TECHNICAL DRAINAGE STUDY
ADDENDUM #1

Skye Canyon Infrastructure Phase 3B & 3C

Job No.: OLY1609.000

Subject: Addendum No.1 to the Technical Drainage Study for Skye Canyon Infrastructure Phase 3B & 3C (CLV DS4953)

\\s01609-000\skye_canyon_phase_3b_3c\drawings\phase_3b_3c\skye\addendum\figures\oly1609_000_exhibit_f_interim_condition_drainage_map.dwg 9/5/2018 3:00 PM Lant Levels

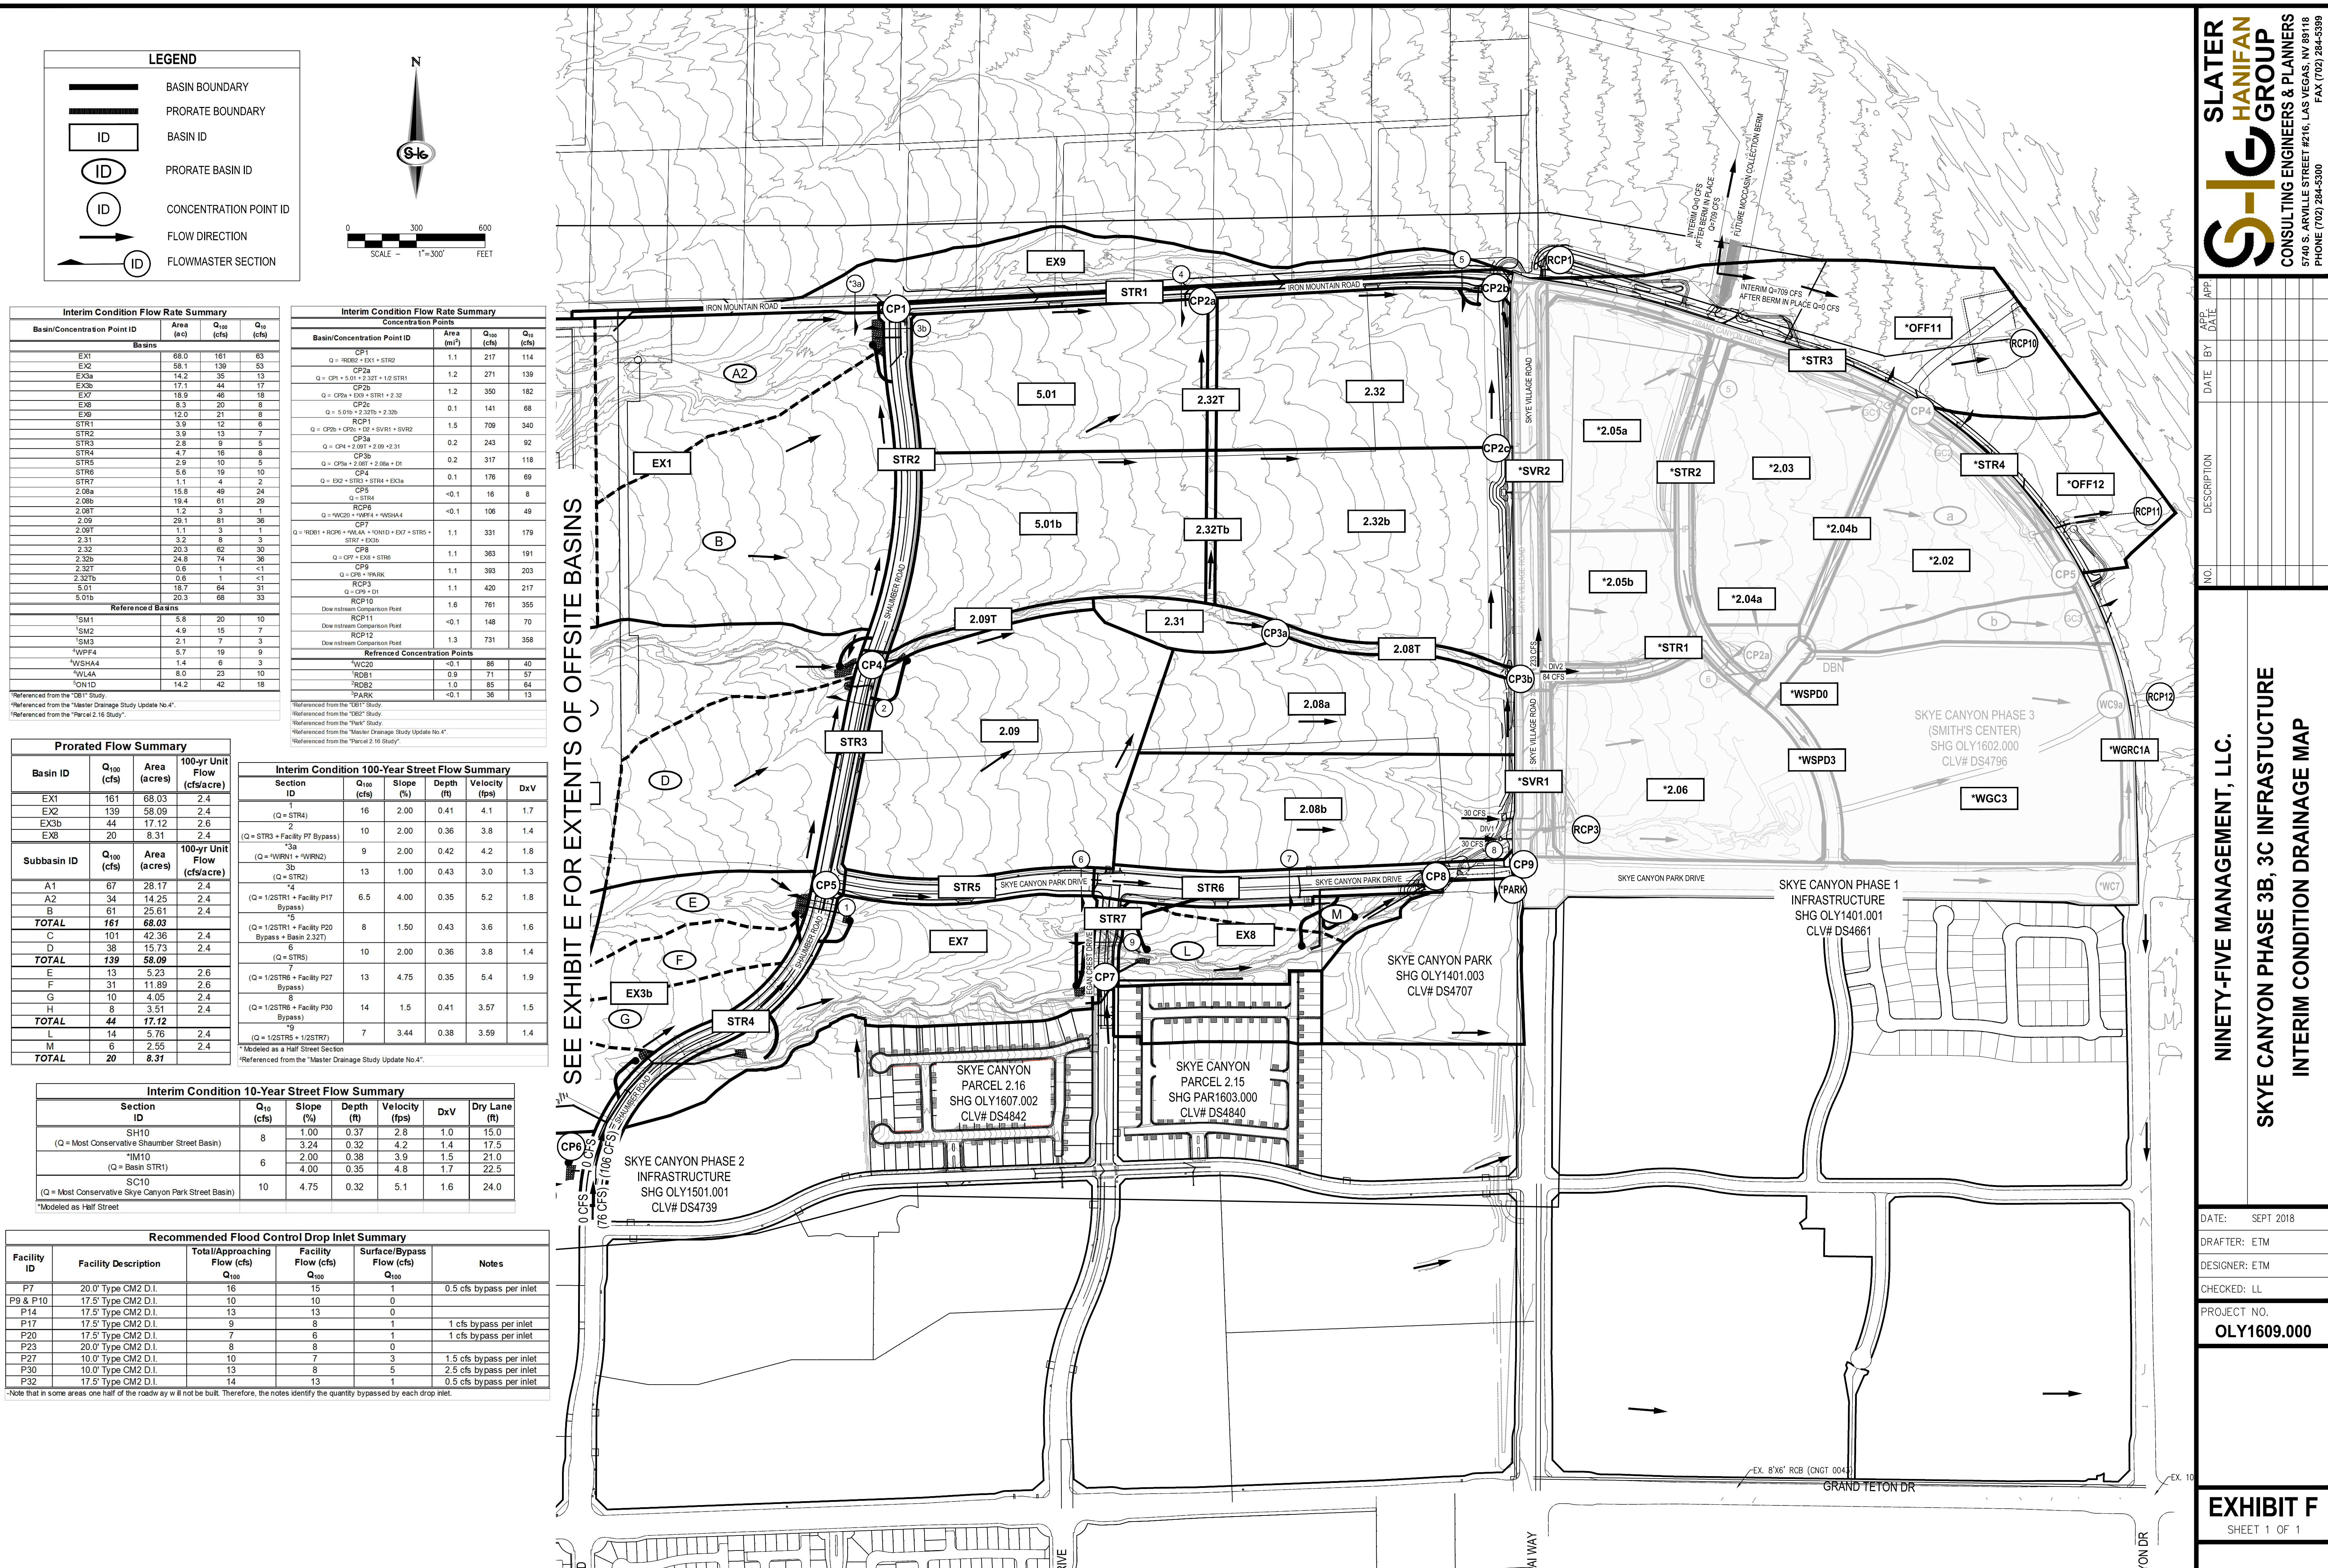
7. **Comment:** *Revise Exhibit F to reflect the proposed interim MPU facility interception Berm/Levee shown on the Moccasin Rd. CCRFCD Flood Control Facility — US95/Kyle Canyon Rd Interchange to Moccasin Rd. (Skye Canyon Developer Funded) plans.*

7. Revise Exhibit F to reflect the proposed interim MPU facility interception Berm/Levee shown on the *Moccasin Rd. CCRFCD Flood Control Facility – US95/Kyle Canyon Rd Interchange to Moccasin Rd. (Skye Canyon Developer Funded) plans*.

Response: Exhibit F is revised to show the interim Moccasin RFCD Facility berm. Flow arrows and descriptions are added to clarify that once the berm is in place, all flow is diverted north along the berm.

F:\01609-000_skye_canyon_phase_3b_3c_drainage\phase_3b_3c_study\addendum\figures\oly1609_000s exhibit 4 ultimate condition drainage map.dwg 9/4/2018 4:11 PM Lent Levitt

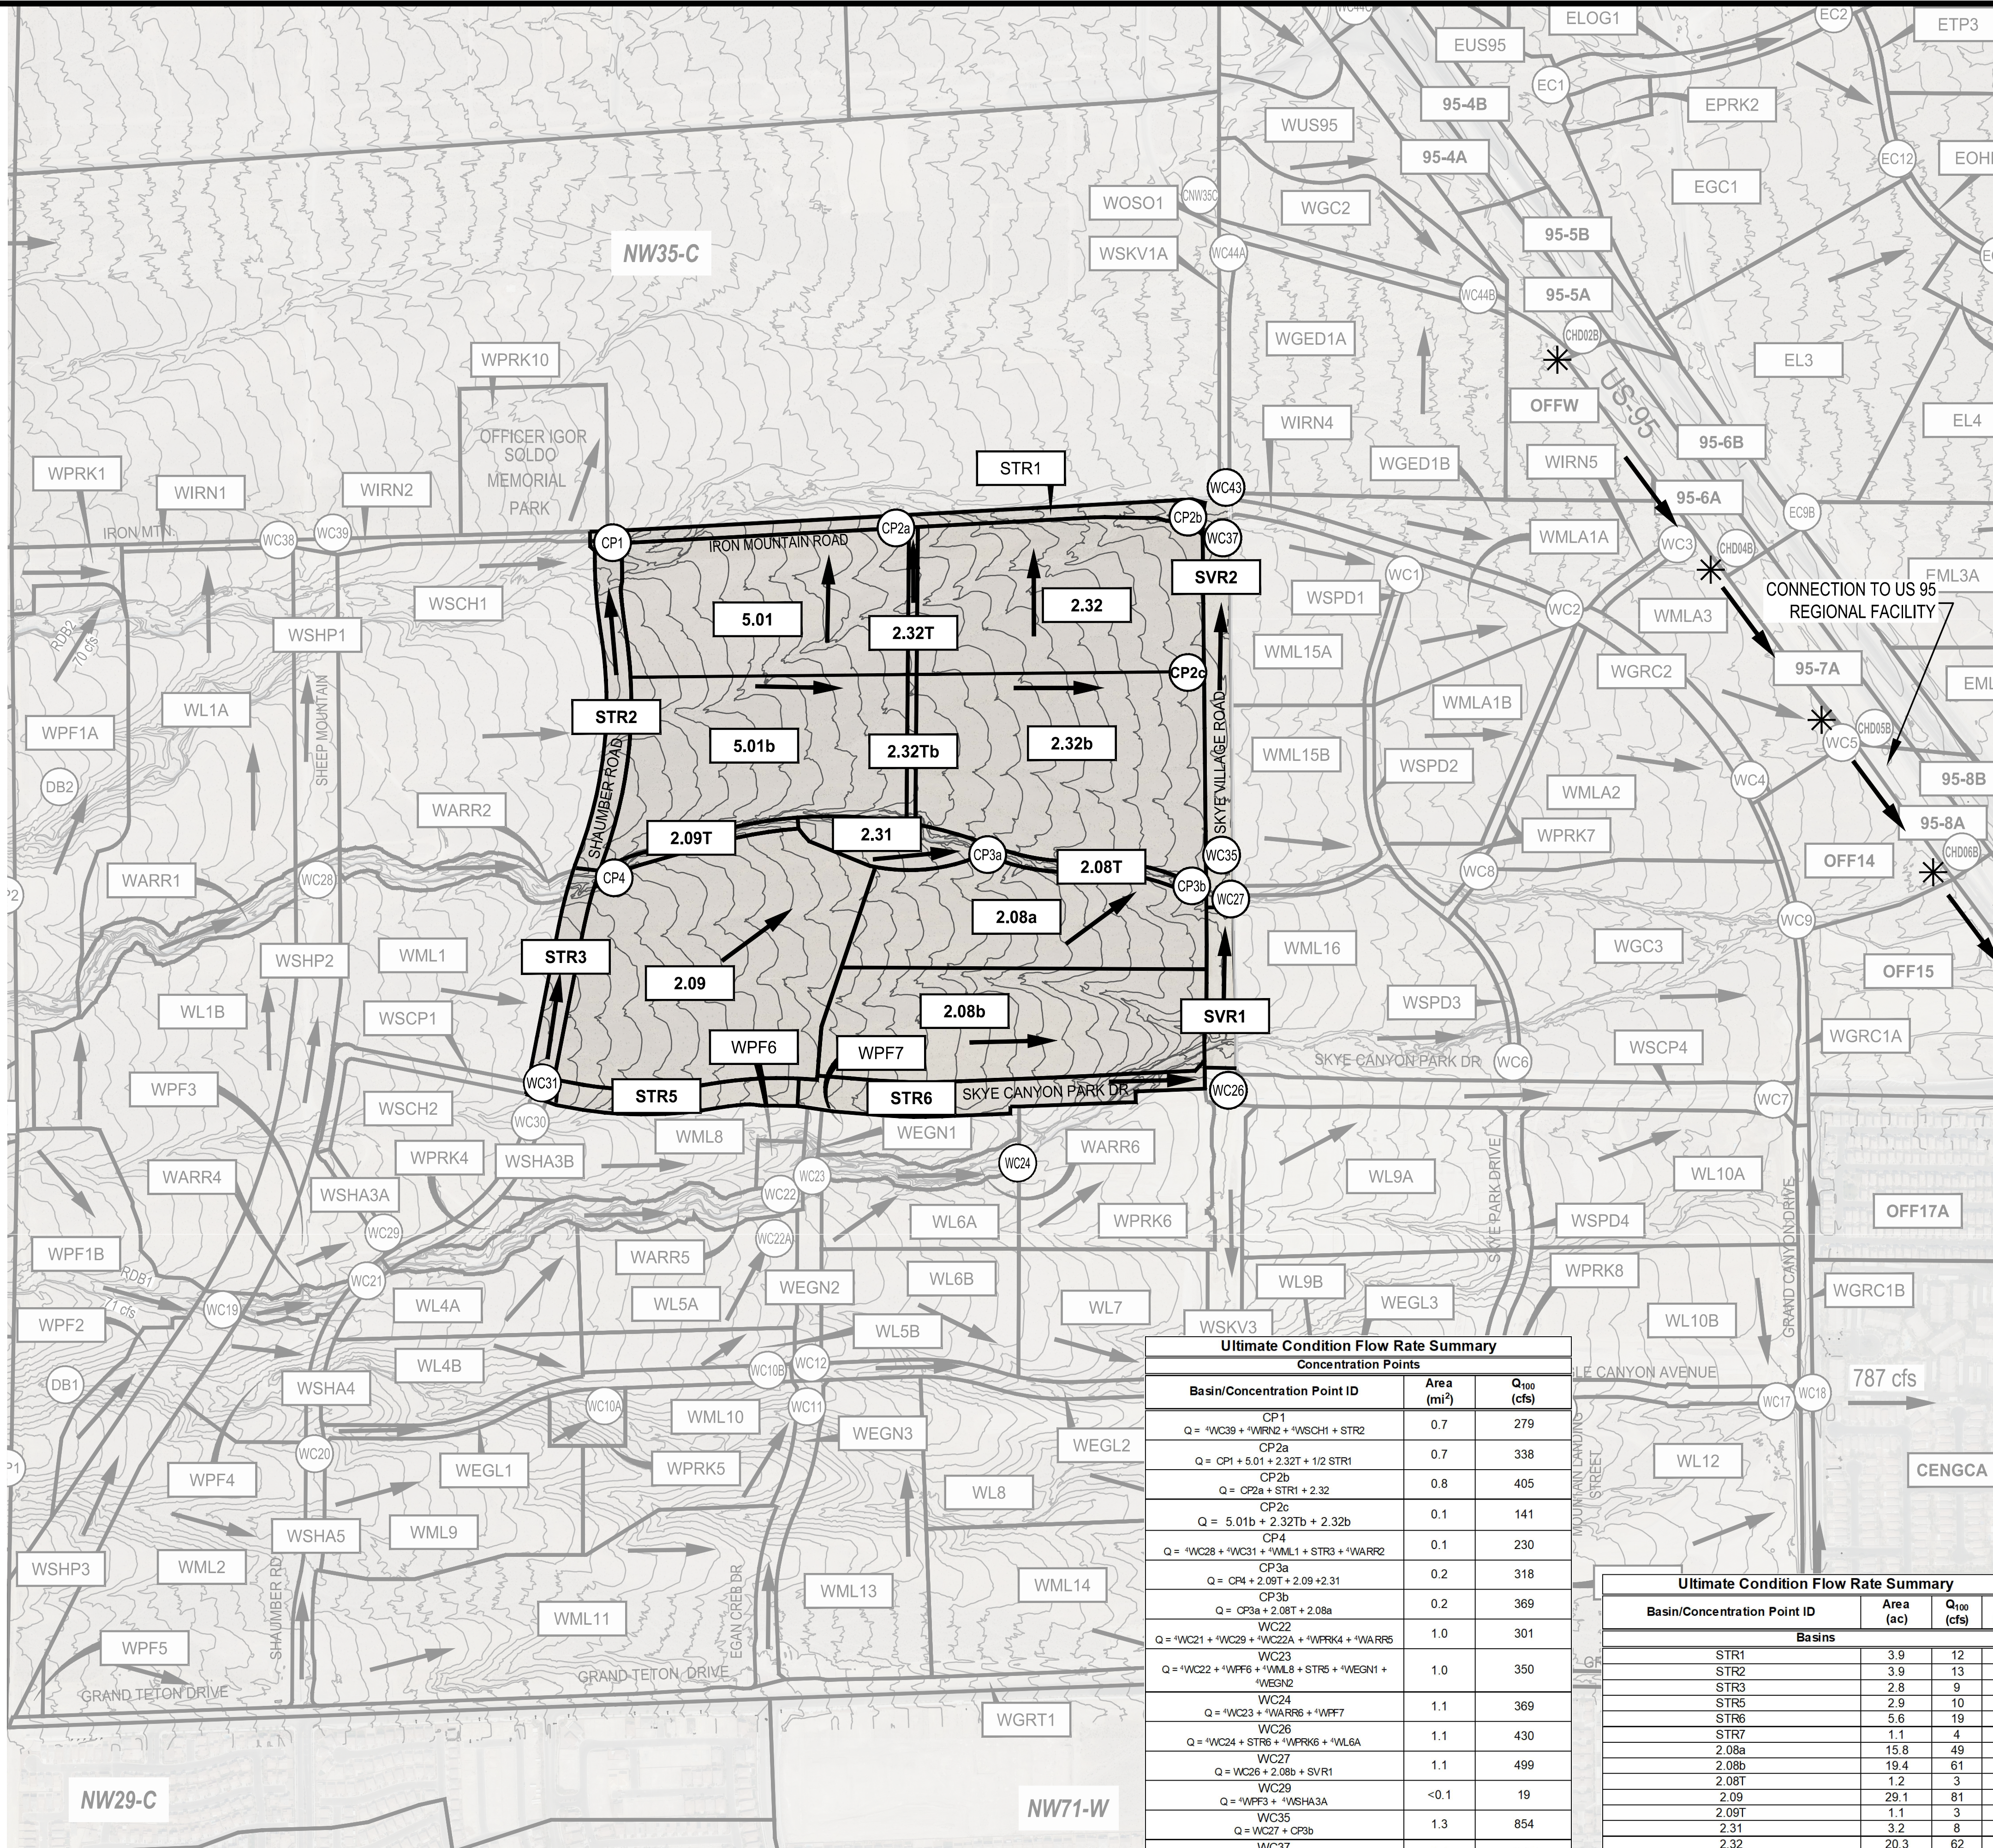
6. **Comment:** *The implementation of the CCRFCD Master Plan is being progressed with the recent bid opening of the NDOT US-95 facilities from the CC-215 interchange north to the Kyle Canyon interchange. Construction of the associated CCRFCD MPU facilities allows for the utilization of the existing MPU facilities constructed with the Horse Interchange. The development of Phases 3A, 3B and 3C west of US-95 shall maximize the flow collection into this facility prior to allowing flows to cross US-95 using the existing culvert system. Provide an Updated **Exhibit G** showing the Ultimate Condition & connection to the existing US-95 facilities. The Ultimate Condition will have the west side of these culvert systems removed, no longer having flows cross US-95 as per the CCRFCD Master Plan.*

Response: The ultimate condition drainage map, Exhibit G, is updated to show existing US 95 frontage road culvert removals, flows conveyed south along US 95, and connection to the US 95 regional storm drain facility.

EXHIBIT H
SHEET 1 OF 1

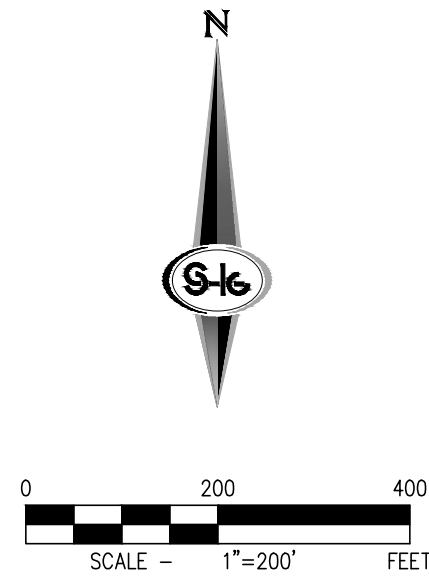
17. **Comment:** *Exhibit H: Clearly label all the street names on the exhibit.*

18. **Comment:** *Exhibit H: Per Page 12 of the drainage study, Facility X13 is revised to 8'x4' RCB from a 60"-RCP as proposed in Phase 3A Infrastructure Drainage Study. Notice that the minimum height of an RCB shall be 5' per City requirements. Revise the facility size to show the minimum 5' RCB height and update the hydraulic calculations accordingly.*

Revise the proposed Facility P22 to per the updated calcs that show the 5' RCB height.

Response: Exhibit H is revised to clearly label streets.

Response: Existing (Phase 3A) and proposed (Phase 3B/3C) RCB facilities in Iron Mountain Road at Skye Village Road are revised to a 7'x5' RCB to meet CLV minimum height requirements. Revised improvement plans are included, a revised WSPGW model is included in Appendix D, and a revised Exhibit H is included in Appendix B.
